**Pacific Gas and
Electric Company™**

February 21, 2024

**RE: Potter Valley Hydroelectric Project, FERC No. 77-CA
2024 Minimum Instream Flow Variance Request Due to Restricted Storage
Capacity**

Figure 1: Average Daily Water Temperature at Gaging Station E-2 and release flow for 2022.

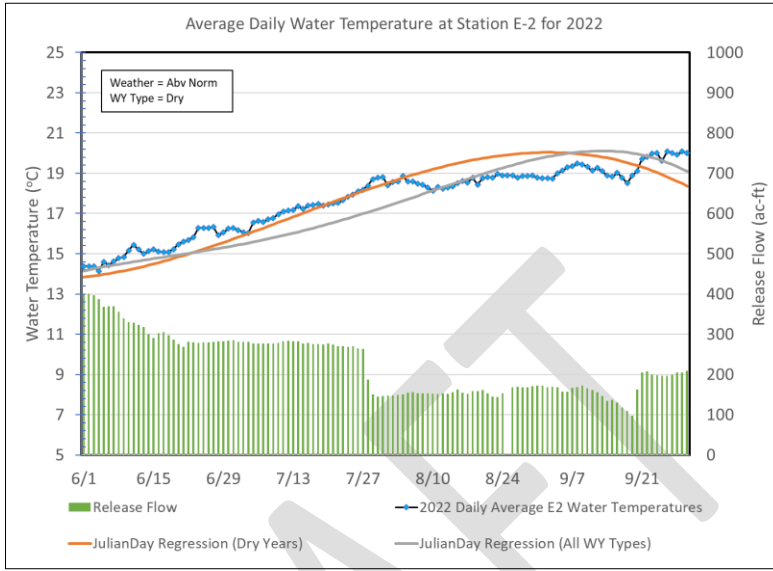
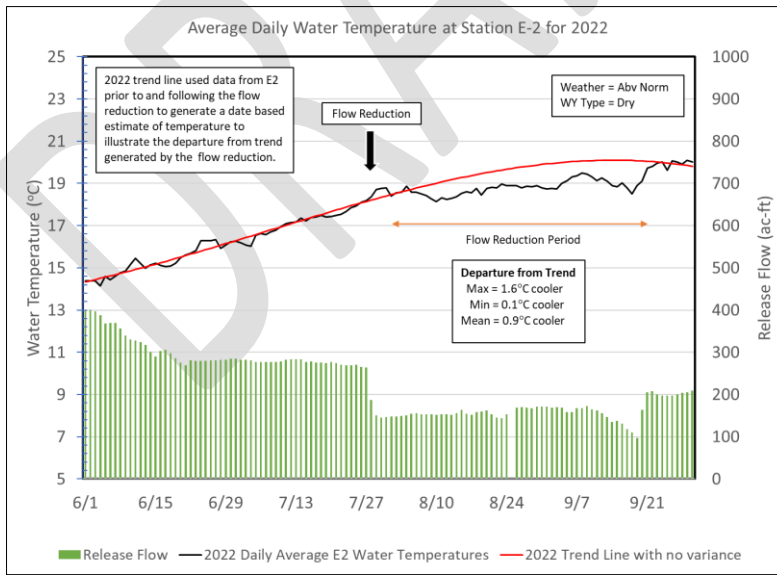
Commented [SM24]: May want to describe what a guidance curve is here rather than force the reader back into Enclosure 2. I think it is the regression lines in Figure 1 and 2.

Commented [PJ26R24]: PG&E concurs, language added

Figure 1: Average Daily Water Temperature at Gaging Station E-2 and release flow for 2022.

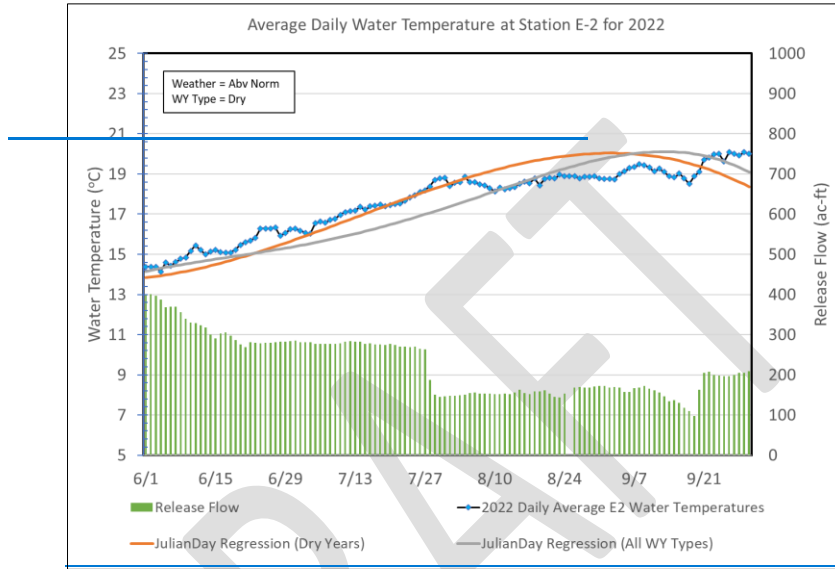
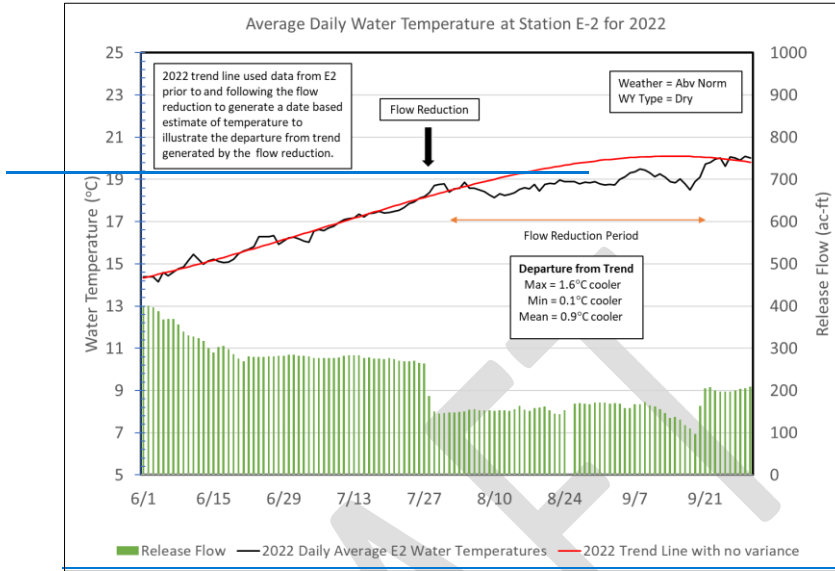
Commented [SM81]: May want to describe what a guidance curve is here rather than force the reader back into Enclosure 2. I think it is the regression lines in Figure 1 and 2.

Commented [AA83R81]: Text added
